CITY OF DULUTH

STAFF REPORT

File Number	10113	Contact	Kyle Deming, kdeming@duluthmn.gov	
Application Type	MU-I Plan Review	Planning Commission Date	12-14-2010	
Deadline for Action	Application Date	11-02-2010	60 Days	01-01-2011
	Date Extension Letter Mailed	11-22-2010	120 Days	03-02-2011
Location of Subject	Northwest corner of 10th Ave. E. and Second St. (East Hillside)			
Applicant	St. Luke's Hospital - Pat Earley	Contact	218-249-5664, pearley@slhduluth.com	
Agent		Contact		
Legal Description	Lots 13-16, Block 55, Portland Division			
Neighbor Letter Date	11-22-2010, sign also posted	Number of Neighbor Letters Sent	21

Construct oxygen storage tanks, electric power transformers, and a 17 stall parking lot to serve St. Luke's hospital and clinic. Please see the attached description of the facilities.

LANDSCAPE PLAN
sheet title
sheet number
L1.0

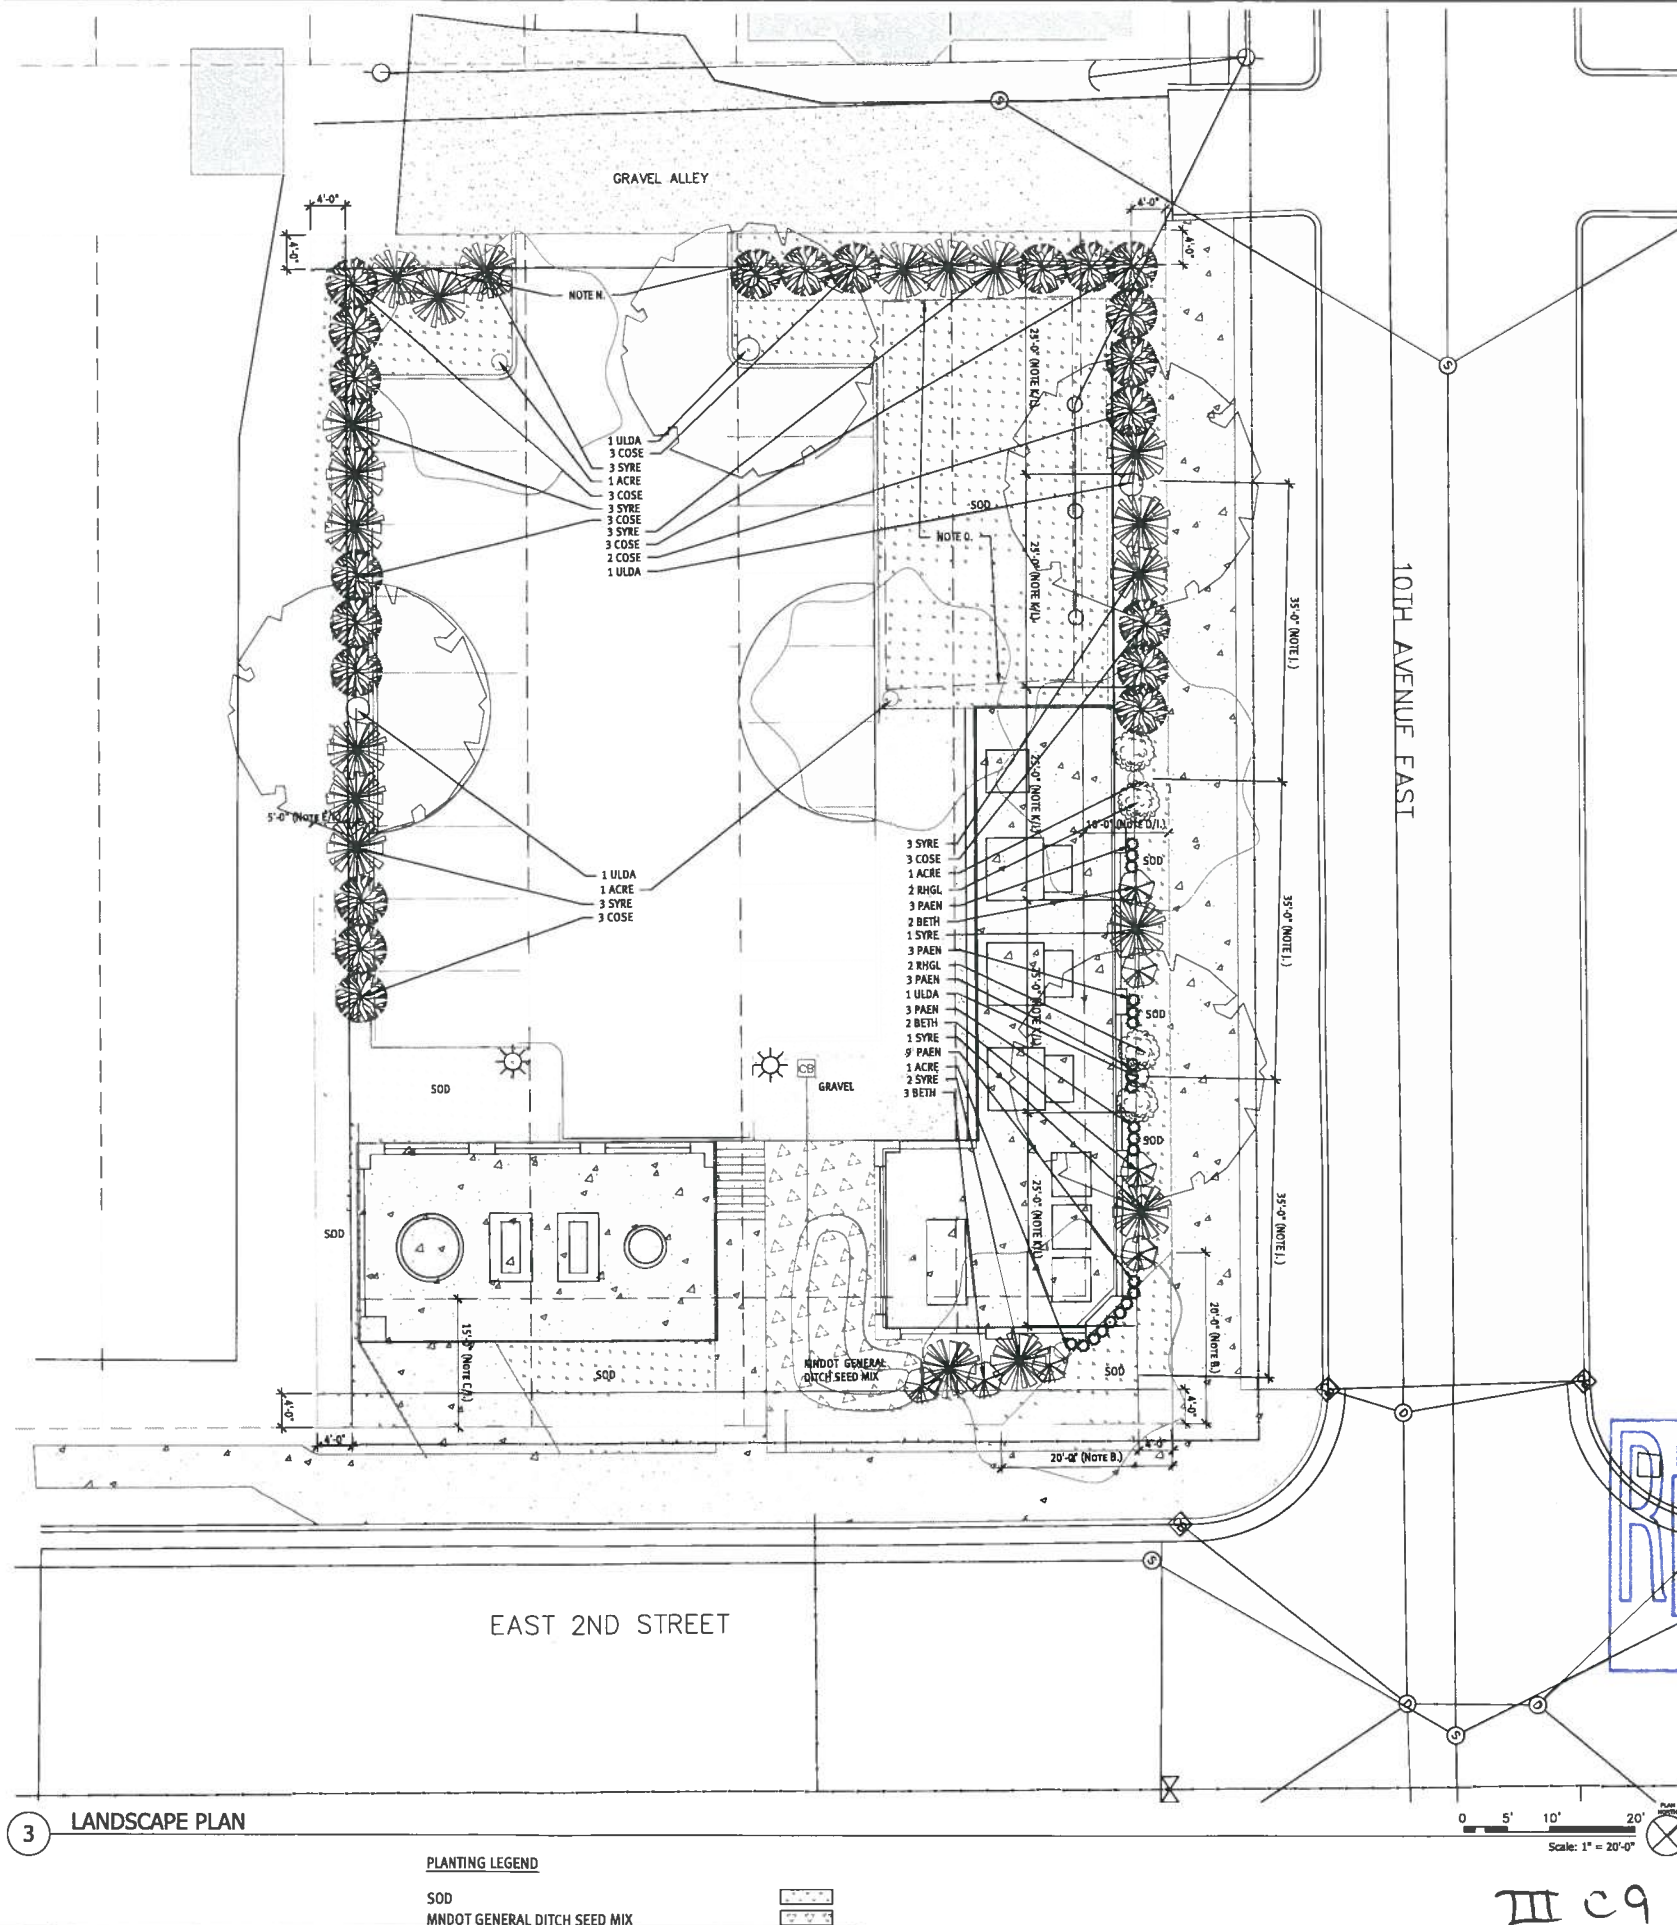
- 4) Sec. 50-25 - Landscaping and Tree Preservation: Landscape plan complies in all areas except for the following: (1) street frontage landscaping required on 2nd St. Applicant asserts, but has not provided evidence, that safety requirements prohibit landscaping within 25' of the oxygen tanks and spacing requirements don't allow for relocation of plant materials in that frontage area. If applicant provides technical evidence to support this, the Land Use Supervisor may approve adjustment (Sec. 50-25.2.J). (2) Concern that the required 6' vegetative screening (Sec. 50-25.4.B and Sec. 50-25.5.B) will not reach the required 75% opacity at the one-year mark given info. on the Arbor Day web page. Will require site review at 1 year mark to verify.

Because the 12/3/2010 plans are lacking (1) documentation of the need for flexibility in applying the street frontage landscape requirements for 2nd Street and (2) a complete Lighting Plan, staff recommends the MU-I plan review be tabled unless these deficiencies are cured before the Planning Commission meeting. If the deficiencies are cured, staff's recommendation is:

- 1) The project be limited to, constructed, and maintained according to the documents submitted by DSGW Architects titled "St. Luke's Hospital Utilities Services Relocation," dated 12/3/2010, Sheets T.1, C1.0, C2.0, L1.0, A1.0, A2.0, A3.0.
- 2) Land Use Supervisor approves adjustment of 2nd Street frontage landscaping, per Sec. 50-25.2.J.
- 3) Building official approves variation in the screening height for tanks, as allowed by Sec. 50-26.4.D.
- 4) Building official approves the sign permit, per Sec. 50-37.13.
- 5) Engineering and Building official approves the storm water permit and erosion controls, per Sec. 50-37.13.
- 6) Any alterations to the approved plans that do not alter major elements of the plan may be approved by the Land Use Supervisor without further Planning Commission; however, no such administrative approval shall constitute a variance from the provisions of Chapter 50.

ELEVATIONS
sheet title
sheet number
A2.0

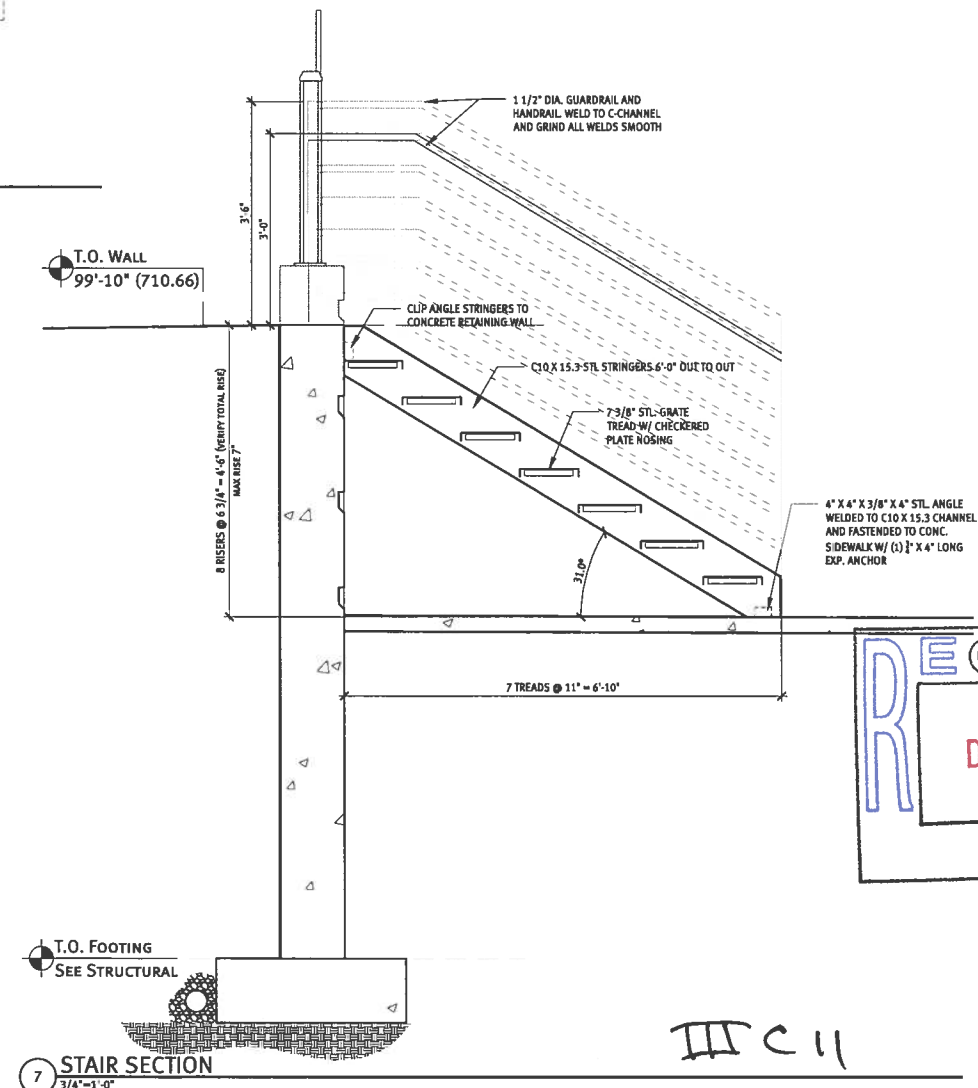
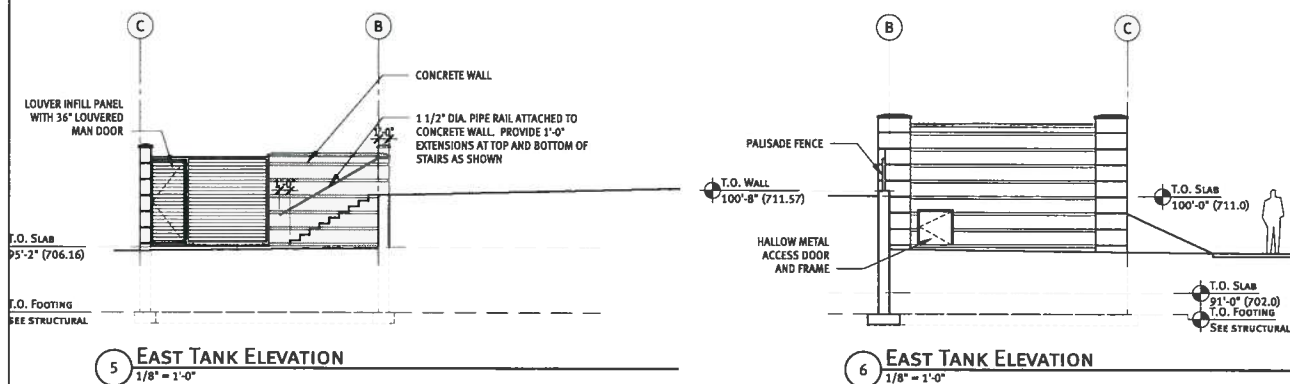
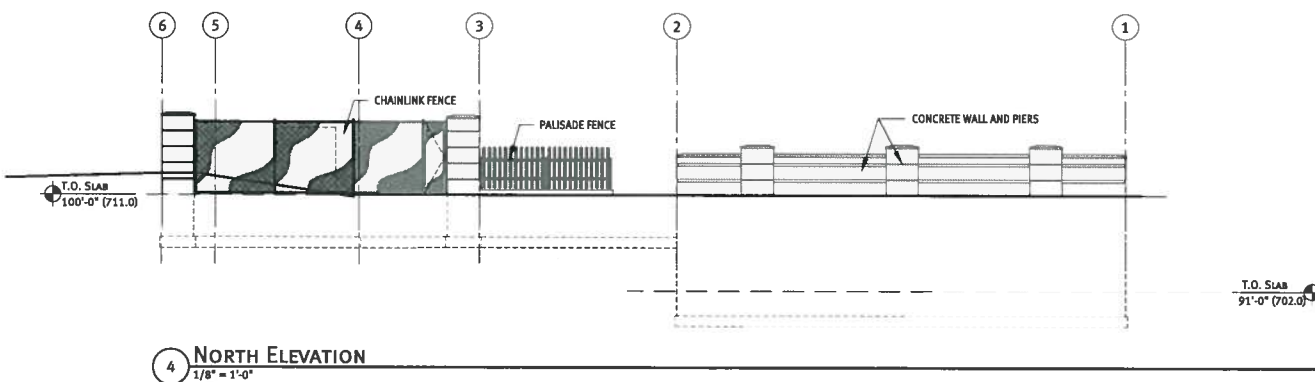
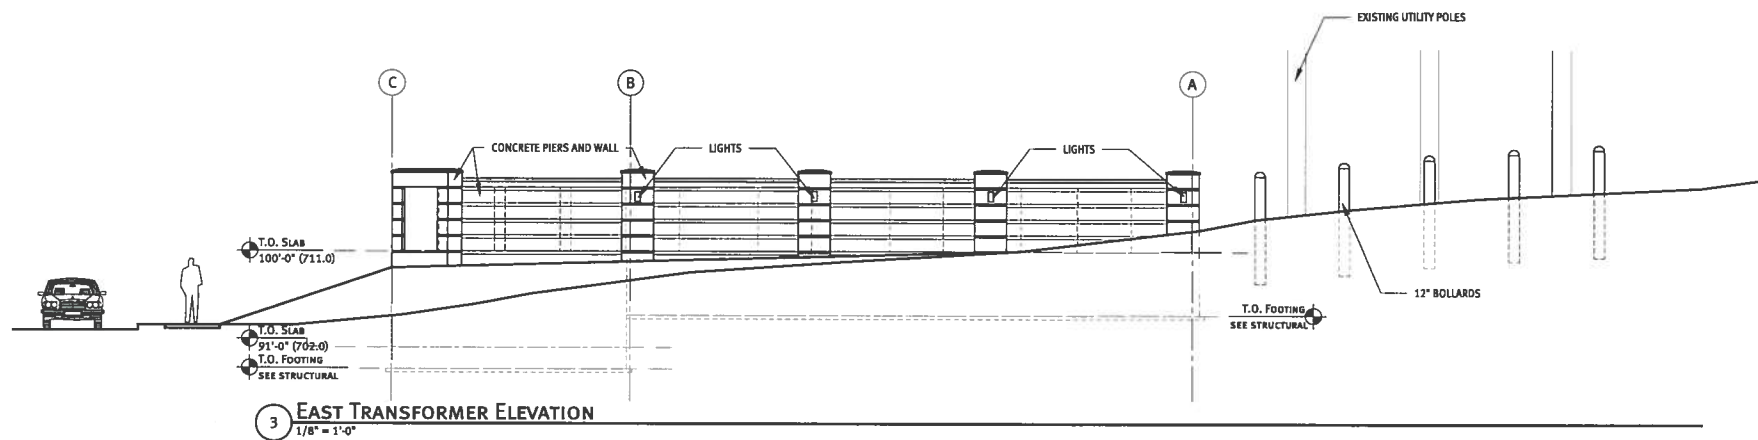
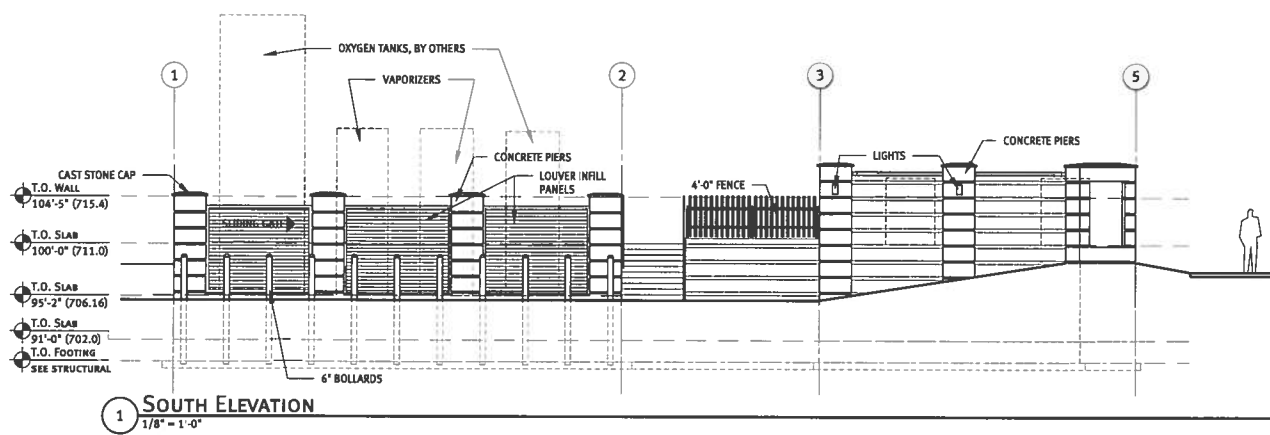
- 5) Sec. 50-26 - Screening, Walls, and Fences: Design meets requirements except for the following: Screening for the oxygen tanks and evaporators is not tall enough to completely screen the equipment (Sec. 50-26.2.B.2). Applicant has provided an 8' tall fence to match other fences on site. Building official will need to approve this variation (Sec. 50-26.4.D).
